**Pre-bid Clarifications No. 1 Dated 22-02-2025 to Pre-bid queries on stipulations of Bid Document against NIB No. 467 Dated 27-11-2024 for “Engineering, Procurement, Construction and Commissioning of Civil, Hydromechanical Works and specified permanent Project Roads for Heo Hydro Electric Project (240 MW) in Shi Yomi District, Arunachal Pradesh”**

**(This Pre-bid Clarifications shall form part of the Bid Document and shall supersede the corresponding stipulations of the Bid Document, wherever these are at variance.)**

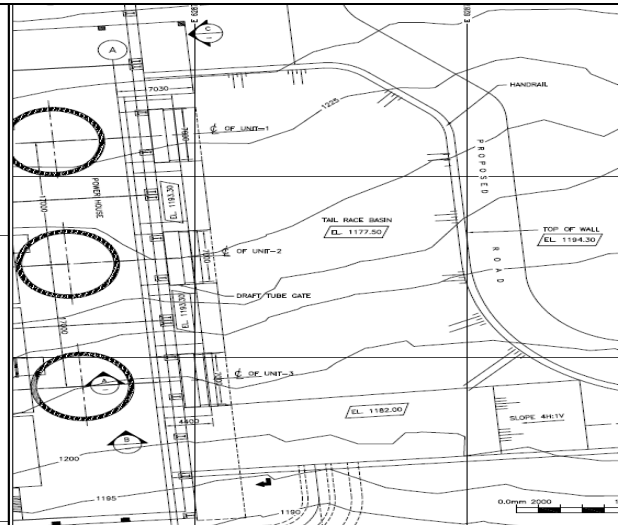
43.	Drawing No.1275-CD-0202/0203	<b>Coffer Dam Section</b> 	The typical section of coffer dam provided in the drawing is for reference and the contractor is free to design suitable type of coffer dam & river diversion duly meeting the "Employers Requirement". Kindly confirm	<b>Please refer Corrigendum No. 3 Dated 07-02-2025.</b> Clause "2.6 Employer's disclaimer regarding information/data provided in Project Profile " of PCC may also be referred to.
